Planning and Building Department

Geotechnical Consultant Approval

Subject: Highland Estates Lots 5-11 Response to County Comments

Date: September 21, 2018
Project No.: 230-1-6
Prepared For: Mr. Jack and Noel Chamberlain
TICONDEROGA PARTNERS, LLC
655 Skyway, Suite 230
San Carlos, California 94070
Re: Response to County of San Mateo
Planning Comments Dated September 5, 2018 on Lots 5 to 11
San Mateo Highlands
San Mateo, California

Sheet Number: **C9.91**
OF

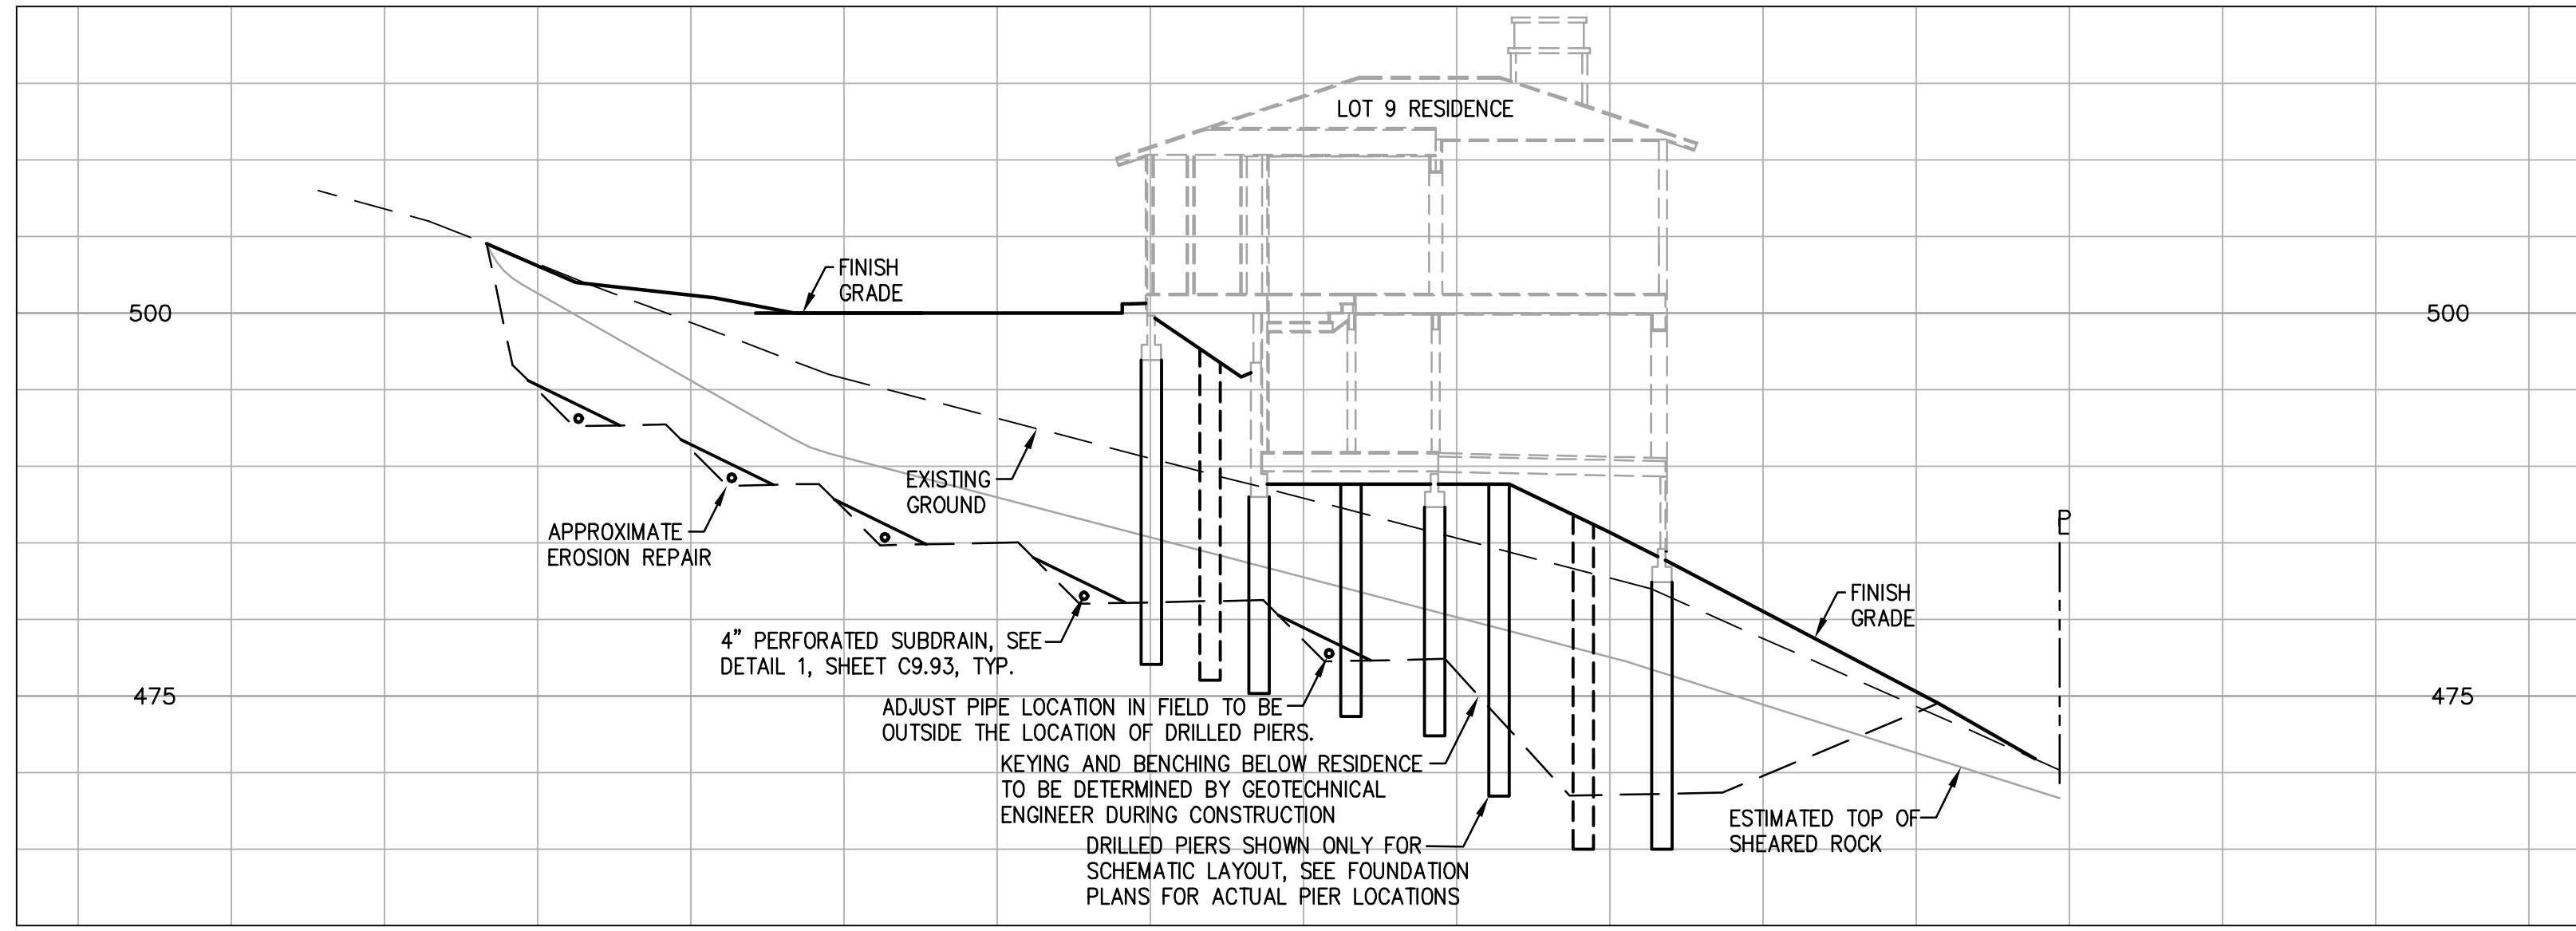
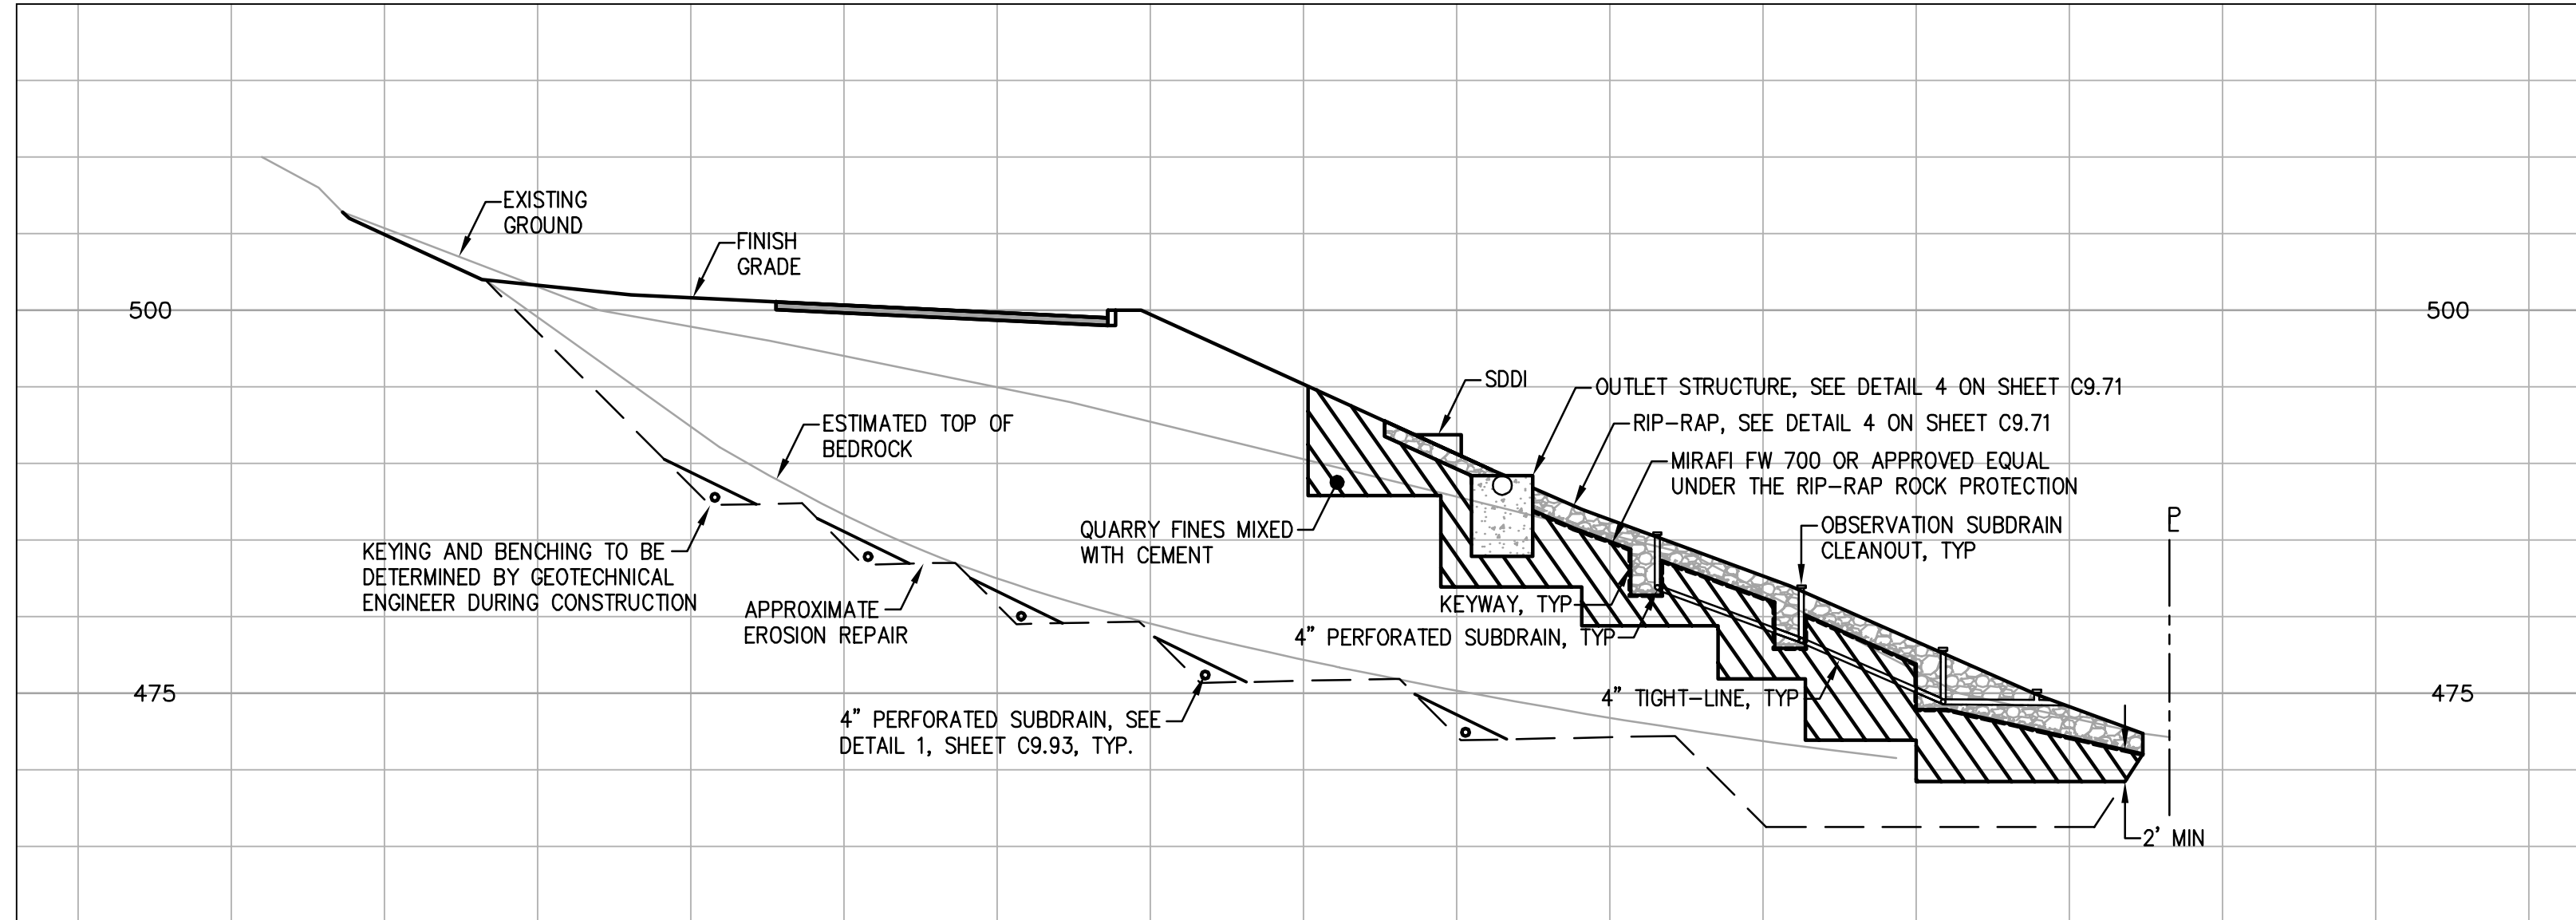
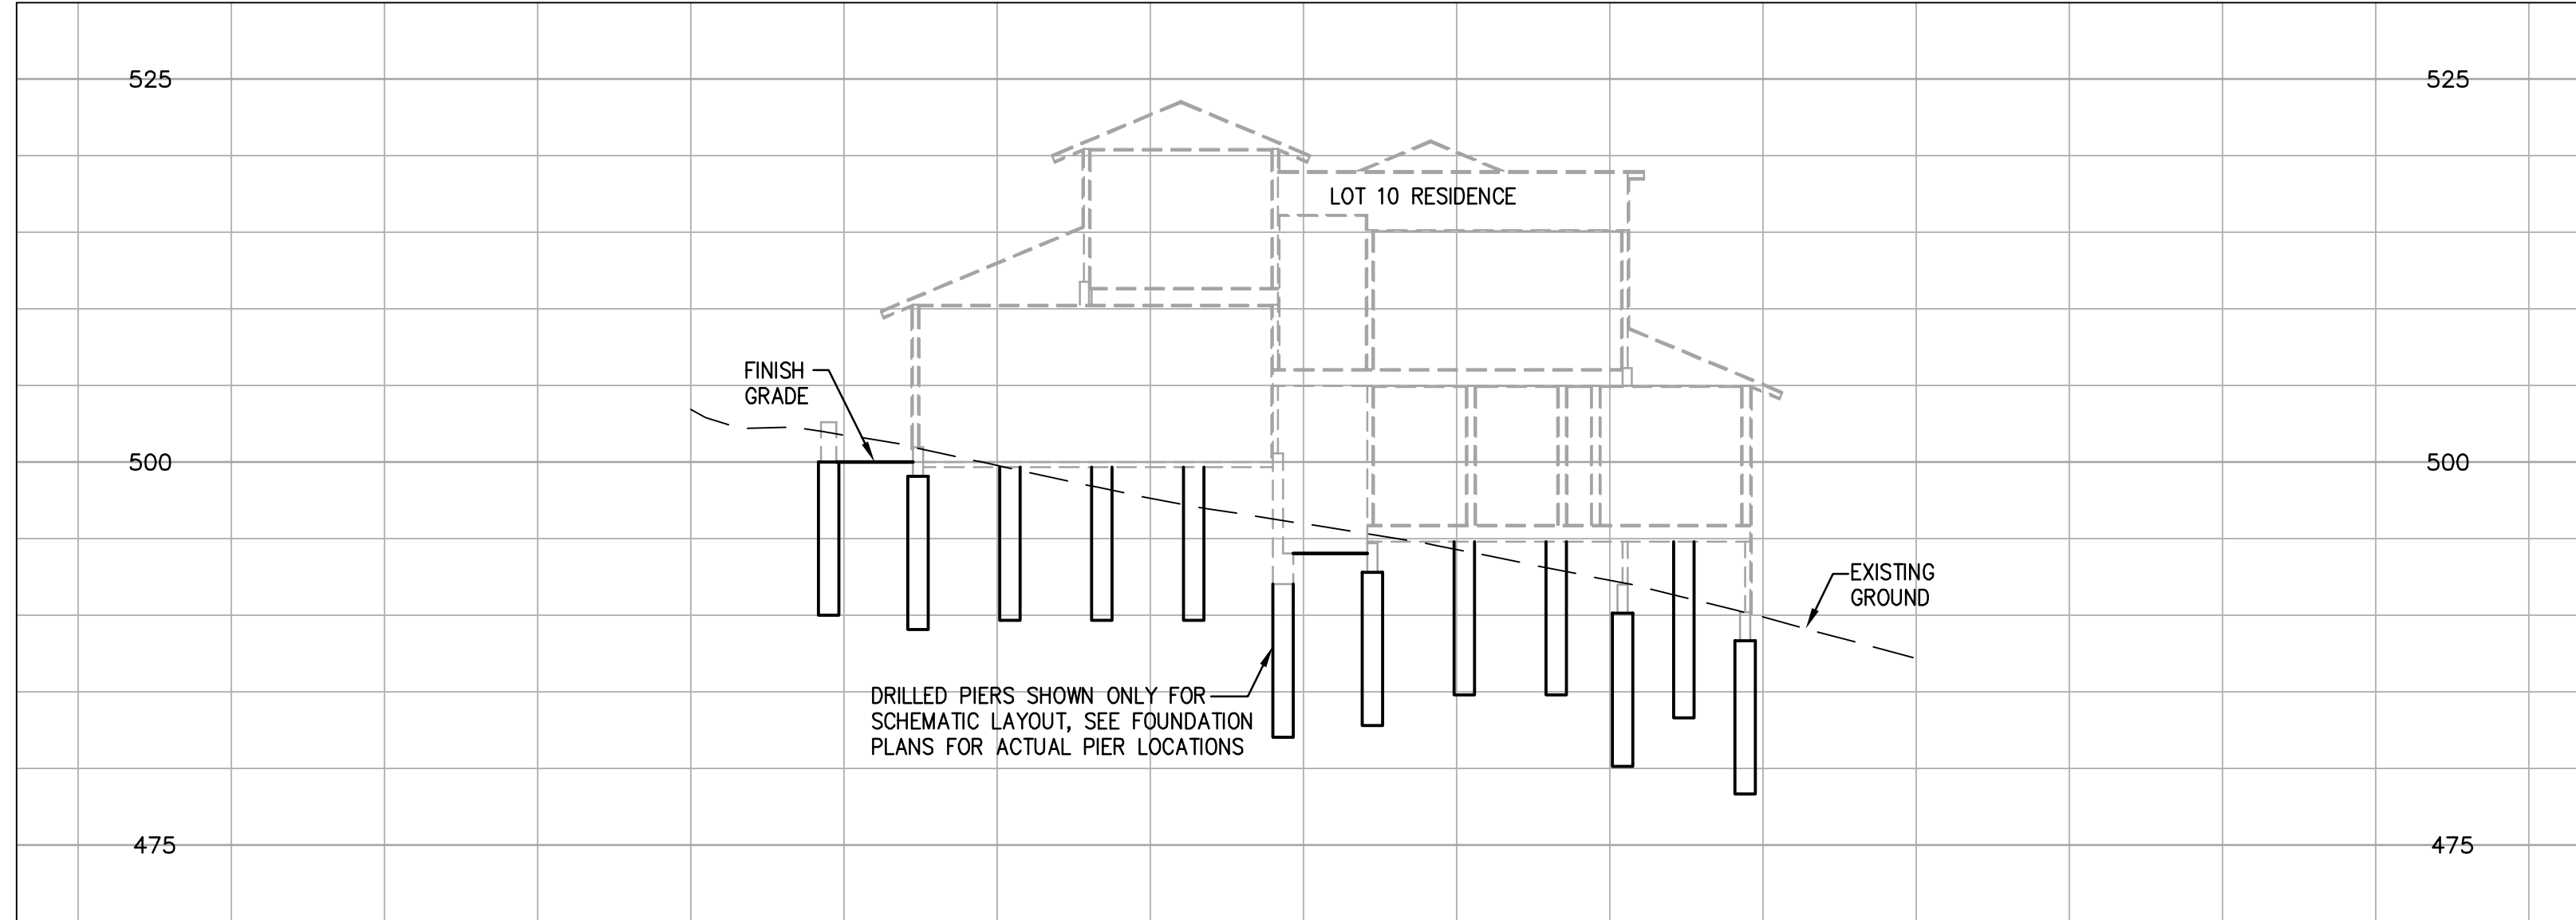
As the slope below the riprap is 2:1 as shown on BKF Sheet C9.71 for Lot 9 (dated 10-8-18), if water must be discharged across the face of a steep fill slope, then County requires the implementation of one of the following measures:

Comment #1: *As the slope below the riprap is 2:1 as shown on BKF Sheet C9.71 for Lot 9 (dated 10-8-18), if water must be discharged across the face of a steep fill slope, then County requires the implementation of one of the following measures:*

As we discussed, the project owner would like to implement the first option to address the above comments. As shown on Sheets C9.71 and C9.93 of the project Civil Plans, the rip rap slope protection will be underlain Marifi FW 700 geotextile fabric or approved equal. We do not recommend the rip rap be hard grouted because that will reduce rock's function of dissipating energy and slowing down the water after being discharged into the rock lined channel. As an alternative to grouting the rock to create an impermeable barrier to isolate the surface water from the underlying fill material, we recommend placing a select fill material consisting of quarry fines mixed with cement beneath the rip rap and geotextile fabric. We have made revisions to Sheets C9.71, C9.91 and C9.93 (see attached) showing the thickness and lateral extent of the select fill material beneath the rock lined channel. We recommend that the Quarry Fines from Stevens Creek Quarry be mixed with bulk cement on-site, moisture conditioned and compacted as recommended in our report. We recommend about 3 percent cement (i.e. 4 pounds of cement per cubic foot of Quarry Fines, compacted in-place). The spreading of the cement would likely need to be done by hand at the job site prior to the placement in the fill. Our representative should be on-site during placement to verify the percentage of cement being used in the fill as well as monitoring mixing of the cement, moisture conditioning, and compaction. The material should be compacted within 2 to 4 hours of the initial mixing of the cement. The cement treated select fill material would not be subject to soil creep.
